Access Compliance Report

Public Rights-of-Way

(Curb Ramps)

Intersection ID: 5407	Main Street: J_W_CLAY_BV	Cross Street: J_M_KEYNES_DR	Location: N
ADA ID: 87702E767067	Ramp Type: Perp	Initial Pass/Fail: Fail	Overall Compliance: No
Severity Score: 13.75			
Codes/Mitigation Info/Possible Solution		Field Measurements/Component Compliance

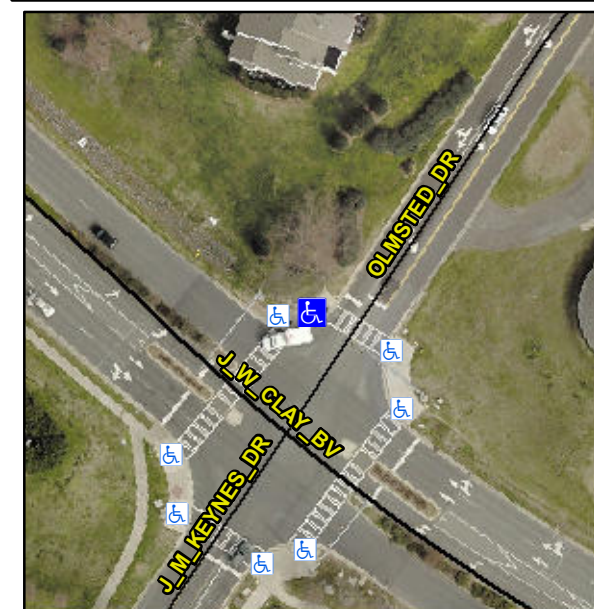
R304.2.2, R304.5.3

Compliance	Description	Data	Compliance	Description	Data
N/A	Ramp Length (in)	96.0	No	Ramp Slope (%)	8.9
Yes	Ramp Width (in)	48.0	No	Ramp XSlope (%)	4.8
N/A	Flare Type LT	N/A	N/A	Flare Type RT	N/A
N/A	Flare Slope LT (%)	N/A	N/A	Flare Slope RT (%)	N/A
N/A	Flare Traversable LT?	N/A	N/A	Flare Traversable RT?	N/A
N/A	Landing Length (in)	N/A	N/A	DWS Provided?	N/A
N/A	Landing Width (in)	N/A	N/A	DWS Contrast?	N/A
N/A	Landing Slope (%)	N/A	N/A	DWS Length (in)	N/A
N/A	Landing X Slope (%)	N/A	N/A	DWS Full Width?	N/A
N/A	Landing Curb? (Y/N)	N/A	N/A	DWS Offset (in)	N/A
N/A	Shared Landing?	N/A			
N/A	Gutter Ponding?	Yes	N/A	Gutter Slope (%)	N/A
N/A	Gutter Lip Ht (in)	N/A	N/A	Gutter X Slope (%)	N/A
N/A	Painted X Walk1?	No	N/A	Painted X Walk2?	N/A
	X Walk 1 Direction	To SE		X Walk 2 Direction	N/A
N/A	X Walk 1 Width (in)	N/A	N/A	X Walk 2 Width (in)	N/A
	X Walk 1 Slope (%)	0.9		X Walk 2 Slope (%)	N/A
	X Walk 1 X Slope (%)	1.6		X Walk 2 X Slope (%)	N/A

Remove & Replace Entire Ramp.
